Author response to Referee #2 comments:

Reviewing of the manuscript open for discussion 'EcoTWIN 1.0: A Fully Distributed Tracer-Aided Ecohydrological Model Tracking Water, Isotopes, and Nutrients' by Songjun Wu et al. submitted to Geoscientific Model Development (Manuscript ID: egusphere-2025-3941).

Figure 1. Model structure of EcoTWIN. As a distributed model, EcoTWIN disentangles the spatial domain into grid cells. In each grid cell, hydrological, isotopic, and nitrogen processes were simulated in canopy, snow, soils, shallow groundwater, groundwater, and channel.

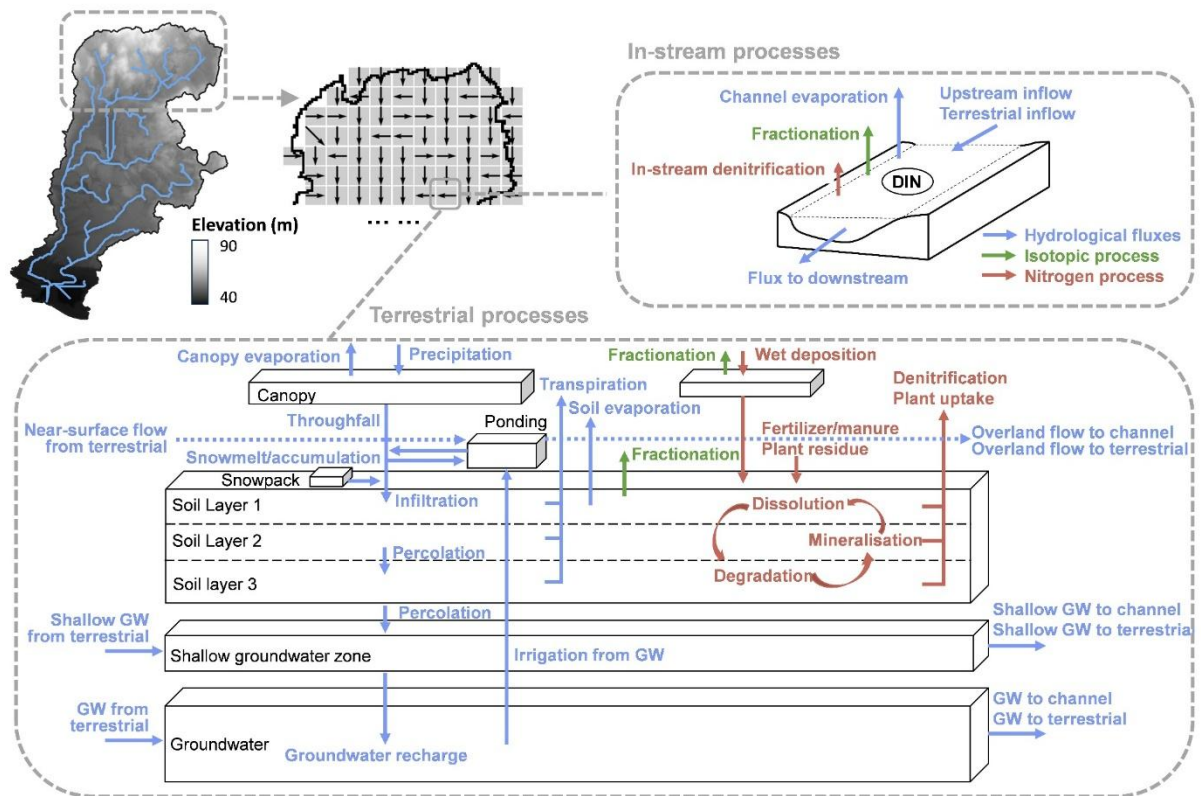
Almost all figures need to be replotted. Here I give some examples. Fig. 1: The texts are too small to read, and the subtitles need add some explanations for the figure, so that the reader is easy to follow it; Fig. 2: the coordinates need to be added, and some important landmarks or rivers information should better be added; the texts are too small to be identified; Fig. 3: the color for the color should be more identifiable, rather than orange and blue two colors; Fig. 4: the time series figures give no information to the reviewer; similar issues also for Fig. 5-7, and the reviewer will NOT list all issues for the figures. The authors should check them carefully and revise them all.

Fig. 1: Irrelevant text has been removed from the inset plot. We have also increased the size of remaining text in inset plot and improved the captions.

Figure 7. The grid-to-grid comparison between simulated snow depth and ERA5 snow depth. The time series show the monthly dynamics of simulated (blue) and observed (orange) values averaged from all grid cells in the watershed, as well as their deviations (grey).

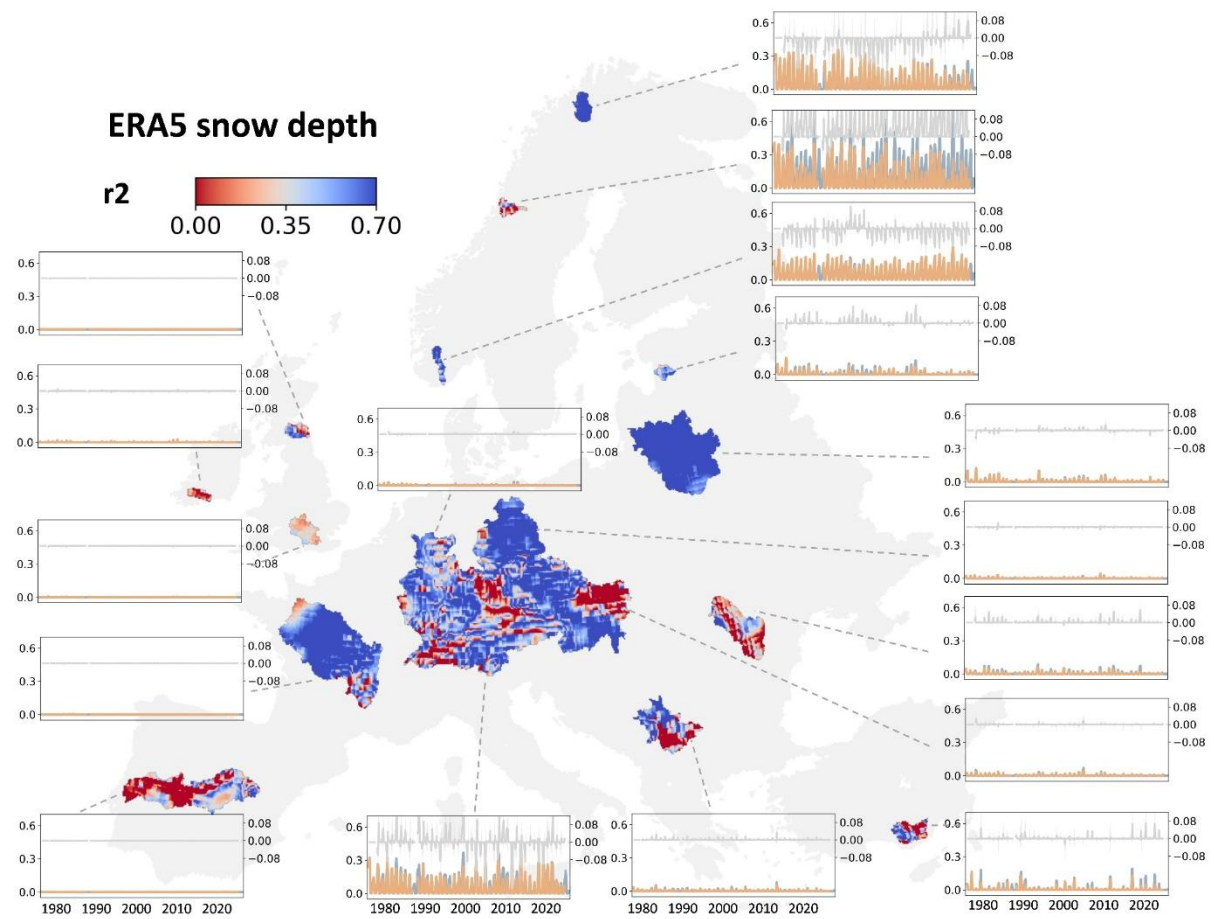
Line 451: ERA5 reanalysis products equal to observations? Please double check it.

Fig. 5-7: The spatial plots show model performance in each grid cell compared to three remote sensing products. These are important validations for the ability of a hydrological model to reproduce uncalibrated hydrological fluxes, or namely the physical consistency. Therefore, we keep the three figures. The ambiguity may originate from the misleading color code of the spatial map, which has been changed to "cool-warm" to differentiate from the inset subplots.

** Yes, the snow depth simulated in model and in ERA5 reanalysis is commensurable, but there are still uncertainties and differences between ERA5 products and real observations. We now use “ERA5 records” to avoid ambiguity.

Finally, the simulated snow depth was compared to the daily snow depth in ERA5 reanalysis products (ERA5 post-processed daily statistics on single levels; 10.24381/cds.4991cf48). Results in Figure 7 show a good agreement between simulations and ERA5 records in most regions with $r^2 > 0.5$, though degradation was found in a few catchments.
